COMMENTS ON THE DRAFT EIR

This document contains comments received during the public review period for the Capitol Annex Draft EIR, which concluded on October 24, 2019. Oral comments from the October 15, 2019 Public Hearing are transcribed and included in Section 1.3, "Public Hearing Oral Comments." Written comments provided within comment letters have also been transcribed into Microsoft Word format to meet the requirements of California Government Code Section 11546.7. This California law requires that all documents that are to be posted on a state website must comply with Section 508 of the American with Disabilities Act (ADA). Section 508 of the ADA applies to online content and has the directive that the content is accessible to those with disabilities. Accessibility is broadly defined as the content being able to be used as effectively by people with disabilities as by those without. For online content, accessibility for individuals with limited sight is of particular concern. Individuals who are blind, or otherwise have limited ability to read written or typed text, often use computer programs broadly categorized as "e-readers" to convert text into spoken words. E-readers a

USE ATRIUM AND EXISTING SIXTH FLOOR, ADD UNDERGROUND SPACE THREE SIDES OF EXISTING ANNEX

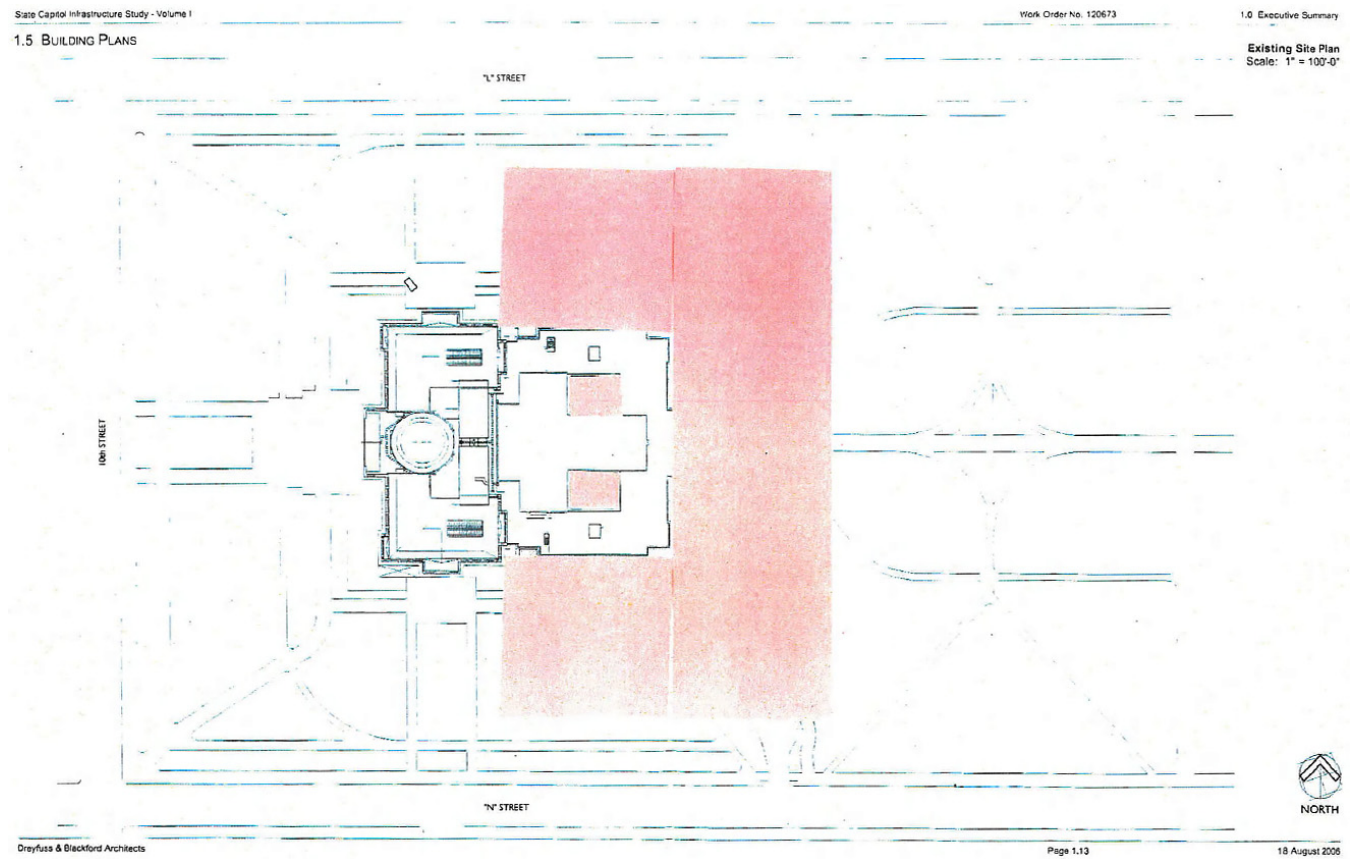
First: For the portion of the Capitol Annex Project that may have detail sufficient for project-level environmental review, the Visitor/Welcome Center, the EIR should include a feasible ramping access design option, to mitigate the impacts, which the intrusions of new above-grade structures – elevator shafts and stairwell covers – would have, to LTS level, relative to the impacts to both historical landscape resources and aesthetic elements of Capitol Park.

Second: For the two other portions of the project, which have considerably less detail, the proposed demolition & building a new, larger Annex building, and proposed 2-acre "underground" parking garage, feasible project-level alternatives to these projects need to be analyzed to allow them to be potentially, LTS, in the case of the parking garage, and, in the case of the Annex building, lessening impacts to historical resources to such a point that it would be the environmentally superior alternative. These new alternatives need to include:

If the atrium spaces were utilized, and the sixth floor fully used, the program could be met by adding approximately 230,000 sf of underground space around three sides of the existing Annex.

USE ATRIUM AND EXISTING SIXTH FLOOR, ADD UNDERGROUND SPACE THREE SIDES OF EXISTING ANNEX

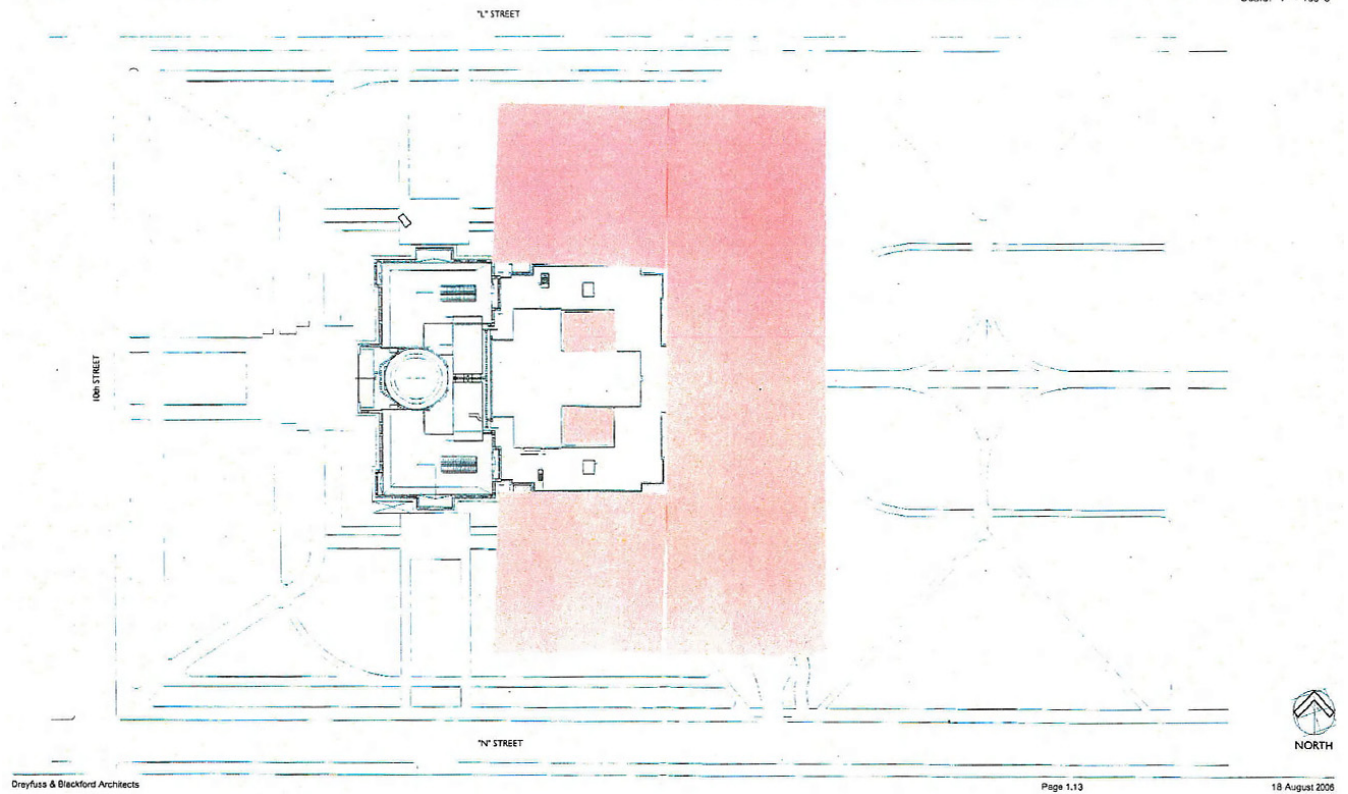
If the atrium spaces were utilized, and the sixth floor fully used, the program could be met by adding approximately 230,000 sf of underground space around three sides of the existing Annex.

MOVE ANNEX TO EAST, USE ATRIUM AND SIXTH FLOOR, ADD SPACE IN BETWEEN

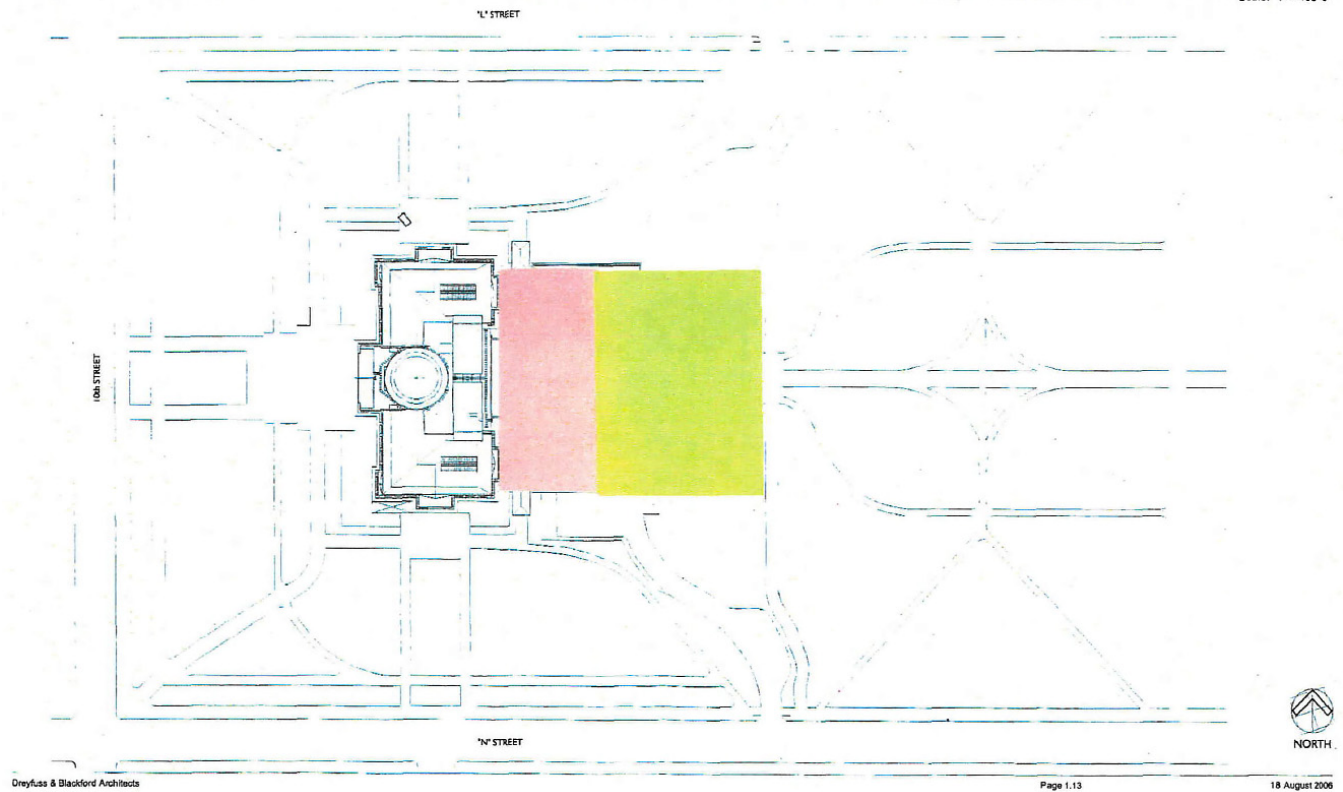
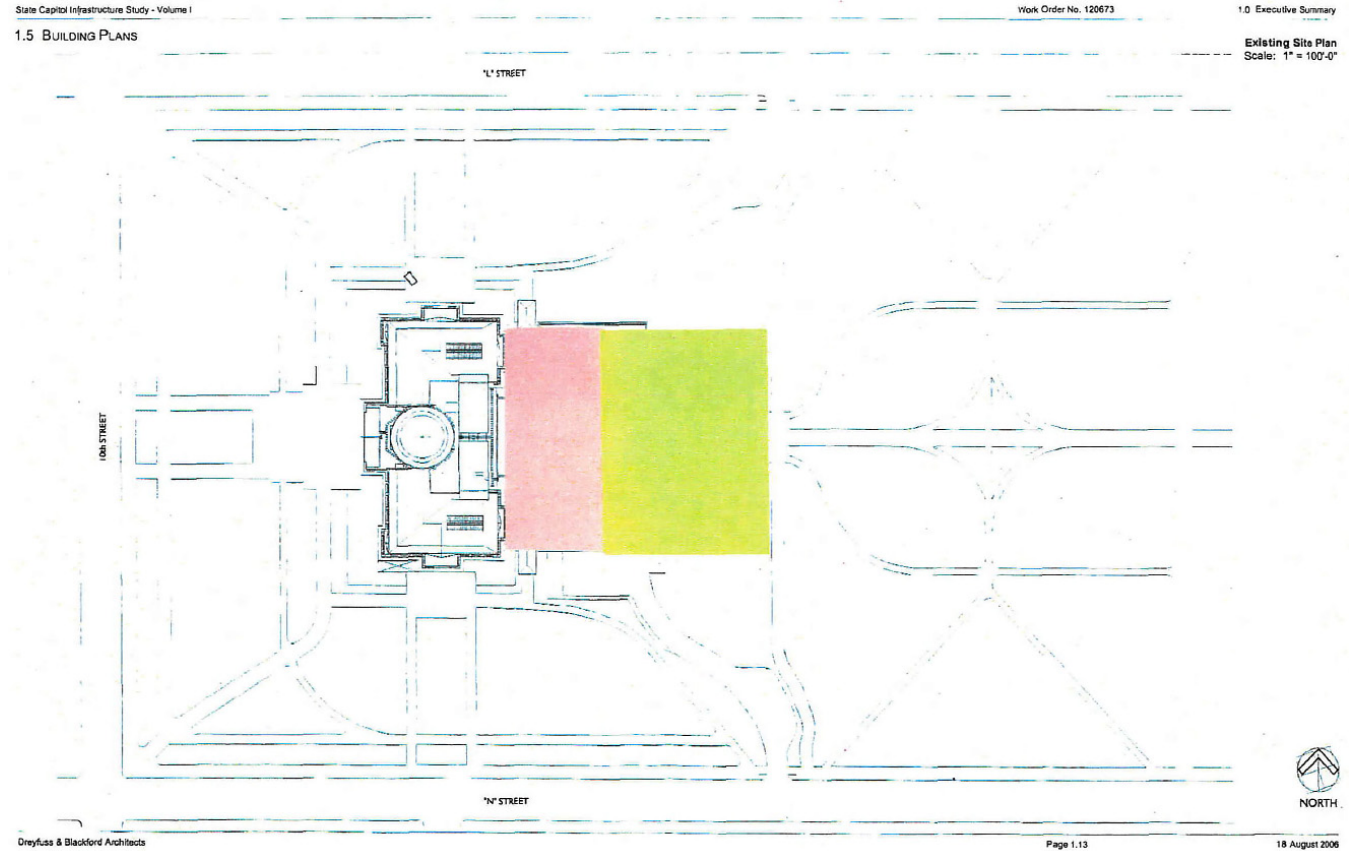
If the atrium spaces were utilized, the sixth floor fully used, and if the existing Annex was moved to the east, the program could be met by adding basement plus five stories in between relocated annex and west wing, better accommodating floor elevation differences.

If the atrium spaces were utilized, the sixth floor fully used, and if the existing Annex was moved to the east, the program could be met by adding basement plus five stories in between relocated annex and west wing, better accommodating floor elevation differences.
